APPLICATION NO.	FILING DATE	FIRST NAMED INVENTOR	ATTORNEY DOCKET NO.	CONFIRMATION NO.	
10/529,239	03/25/2005	Kang Mo Choi	9988.219.00 2549		
	7590 03/08/200 ONG & ALDRIDGE L	EXAMINER			
1900 K STREE	T, NW	REESE, DAVID C			
WASHINGTON	N, DC 20006	ART UNIT	PAPER NUMBER		
		3677			
SHORTENED STATUTORY	PERIOD OF RESPONSE	MAIL DATE	DELIVERY MODE		
3 MON	NTHS	03/08/2007	PAPER

Office Action Summary		Application	lication No. Applicant(s)						
		10/529,23	9	CHOI ET AL.	•				
		Examiner		Art Unit					
		David C. F		3677					
Period fo	The MAILING DATE of this communication appears on the cover sheet with the correspondence address Period for Reply								
A SHORTENED STATUTORY PERIOD FOR REPLY IS SET TO EXPIRE 3 MONTH(S) OR THIRTY (30) DAYS, WHICHEVER IS LONGER, FROM THE MAILING DATE OF THIS COMMUNICATION. - Extensions of time may be available under the provisions of 37 CFR 1.136(a). In no event, however, may a reply be timely filed after SIX (6) MONTHS from the mailing date of this communication. - If NO period for reply is specified above, the maximum statutory period will apply and will expire SIX (6) MONTHS from the mailing date of this communication. - Failure to reply within the set

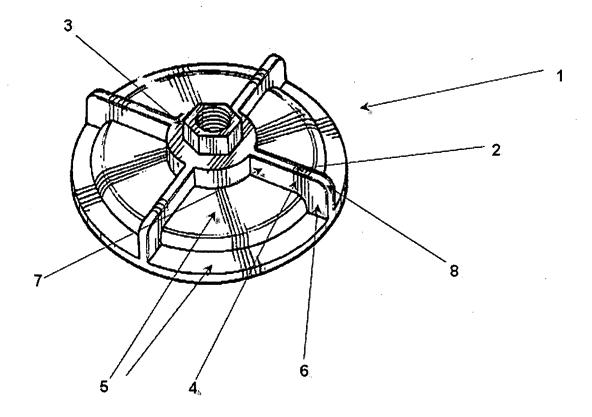
[6] Claims 1-21 and 23-25 are rejected under 35 U.S.C. 102(b) as clearly anticipated by Nelson, US-D427,053, because the invention was patented or described in a printed publication in this or a foreign country, or in public use or on sale in this country more than one (1) year prior to the application for patent in the United States.

As for Claim 1, Nelson discloses of a lock nut (1) (see figure below) [for a leg assembly of electric home appliances], comprising:

a plurality of ribs (2) extending in a radius direction from a circumference of a hub (3), and having a side (4) over which [a tool or finger for rotating the hub about the leg bolt]; and a supplementary member (5) provided [allowing the wrench or finger to access from the radius direction of the hub (3) to the side (4)], and coupling the ribs (2).

Re: Claim 2, wherein the height of the rib (2) is same as or lower than that of the hub (3), and the height of the supplementary member (5) is lower than that of the rib (2).

Re: Claim 5, wherein at least one of both sides of the rib (2) gets larger (6 compared with 7) from the hub (3) toward an end to the rib (2).

Re: Claim 7, wherein the supplementary member (5) comprises an extension member (5) extended from a circumference of the hub (3) to a space between the ribs (2).

Re: Claim 9, where a first side of both sides of the rib (2) is inclined so as to be gradually thickened (6 compared with 7) from an upper part of the rib (2) to the extension member (5), and a second side (adjacent 4, the other side) thereof is inclined such that it get thicker from a lower part of the rib (6 compared with 7) to the extension member (5).

Re: Claim 12, wherein the extension member (5) is inclined such that a first end (inner 5) of thereof of being coupled with the hub (3) is higher than a second end (outer 5) thereof being adjacent to the end portion of the rib (2).

Re: Claim 14, wherein an end portion of the extension (5) is provided to be adjacent to a lower part or upper part of the end portion of the rib (2) such that a single exposed area of a portion being adjacent to the end portion of the rib on the sides becomes larger (see outer 5 compared with inner 5).

Re: Claim 18, wherein the supplementary member (5) comprises a rim (outer 5) for coupling the end portion of the ribs (2).

Re: Claim 21, wherein one (outer 5) of two rims (inner and outer 5) located both sides of the end portion of the rib (2) is coupled with the upper part of the rib (2), and the other rim (inner 5) is coupled with the lower part thereof.

Re: Claim 25, where a first side of both sides of the rib (2) is inclined such that it gets thicker (6 compared with 7) from an upper part of the rib (2) to the extension member (5), and a second side (adjacent 4, the other side) thereof is inclined such that it get thicker from a lower part of the rib (6 compared with 7) to the extension member (5).

Re: Claim 26, Nelson discloses wherein the extension member (5) is inclined such that a first end (inner 5) of thereof of being coupled with the hub (3) is higher than a second end (outer 5) thereof being adjacent to the end portion of the rib (2).

Re: Claim 28, Nelson discloses wherein the rim (outer 5) is perpendicularly extended from the end of the extension member (inner 5) to an upper part or lower part of the rim (2).

Re: Claim 30, Nelson discloses wherein the coupling portion of the rib (2), the extension member (5), and the rim (outer 5) is rounded (8).
